ADDENDUM #2

TO CONTRACT DOCUMENTS FOR: Project #CP245321 – Patient Care Tower – T1230 MRI Room

PREPARED FOR: The Curators of the University of Missouri

25 FIRST FLOOR - FINISHED FLOOR PLAN
1/4" = 1'-0"

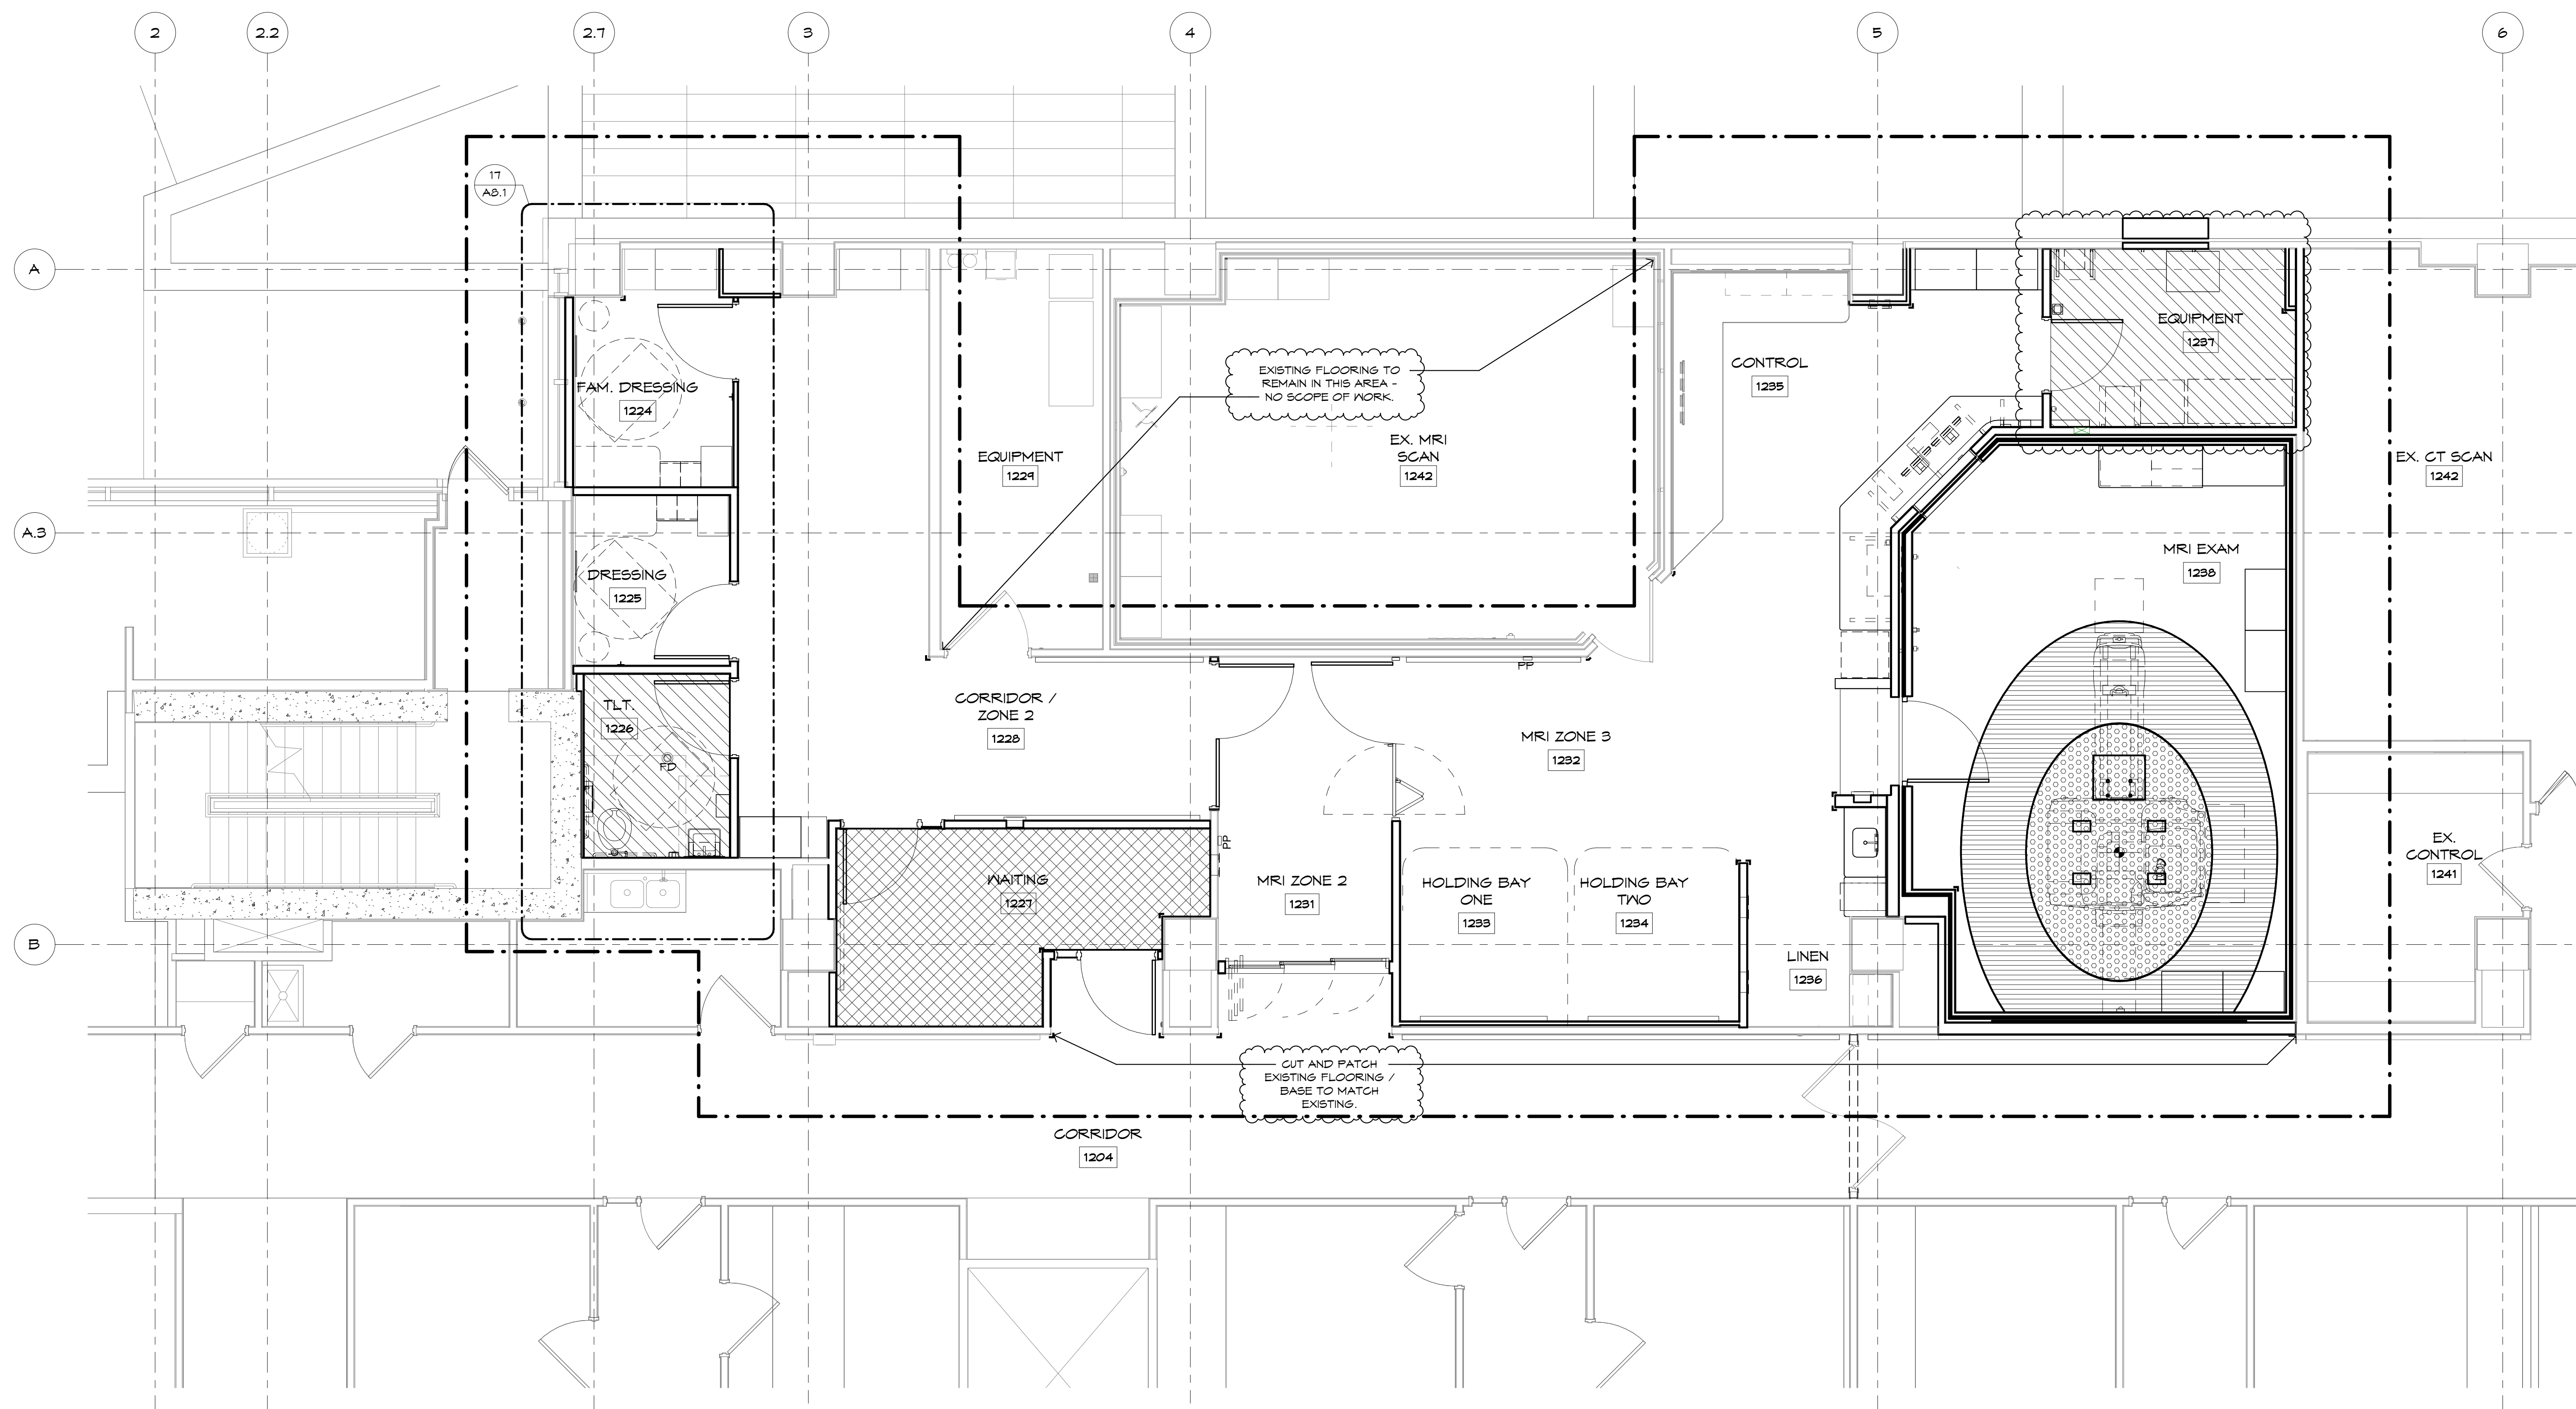
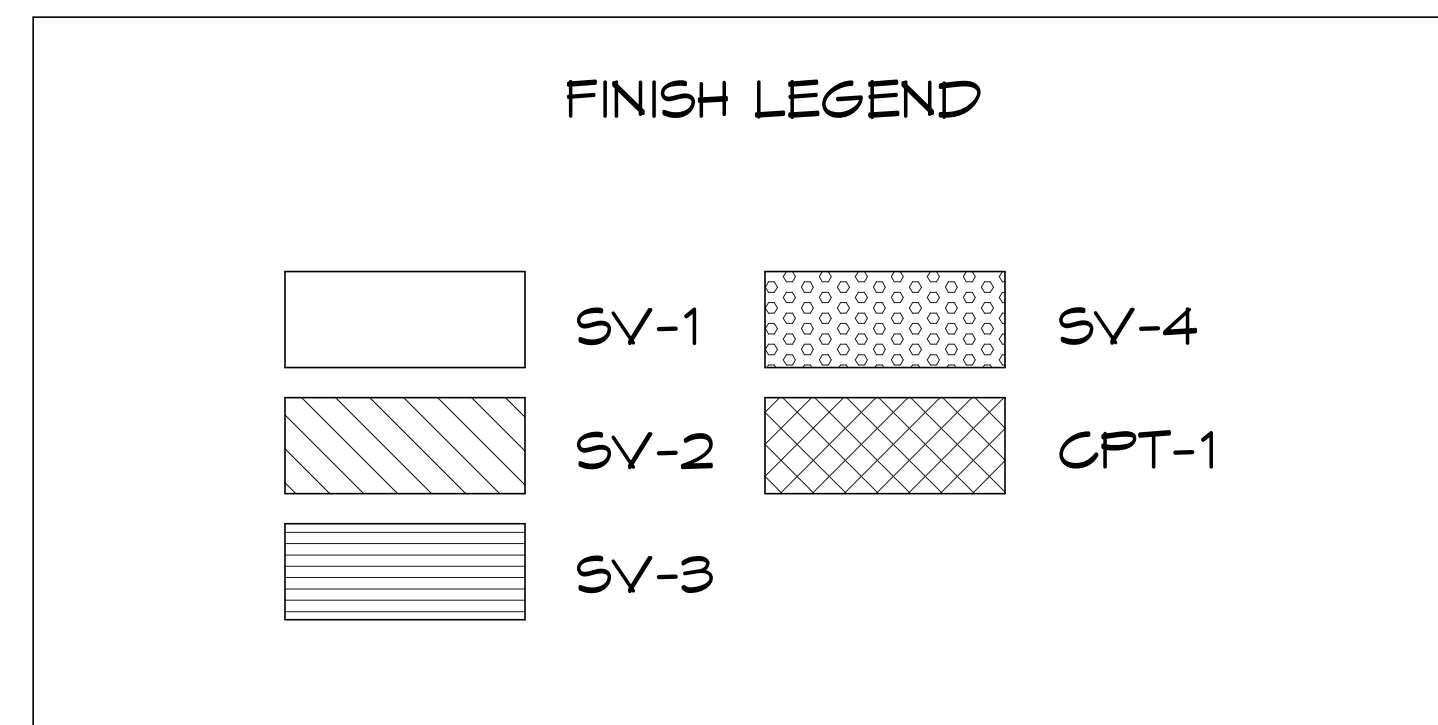
- 4) A5.3 – Finish Floor Plan
 - a. Finish Floor Plan 25/A5.3 – **ADDED** additional notes to finish floor plan.
 - b. Color and Material Schedule – **MODIFIED** Description for SV-3 / SV-4.

3 FAM. DRESSING - NORTH ELEVATION
3/8" = 1'-0"

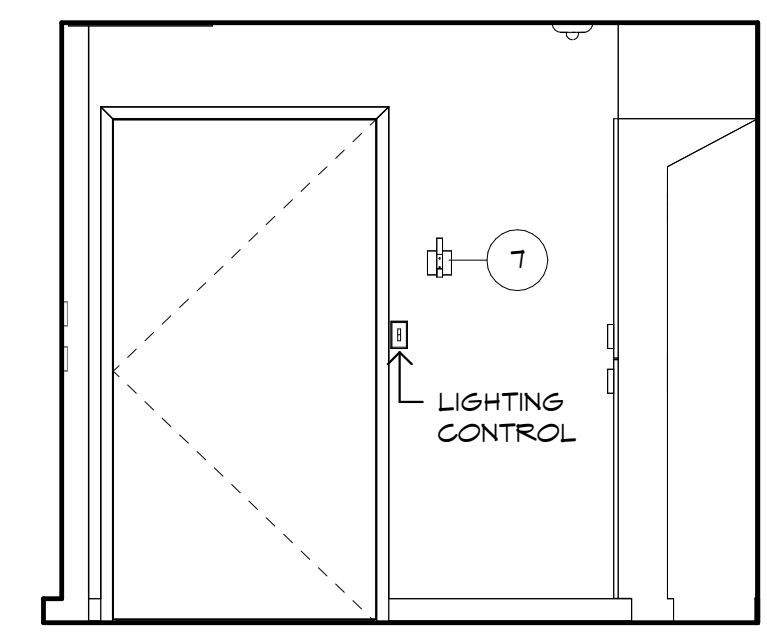
- 5) A8.1 – Interior Elevations
 - a. **MODIFIED** Elevations 3 & 27 to reflect scope outlined in changes to Sheet A2.1 above.
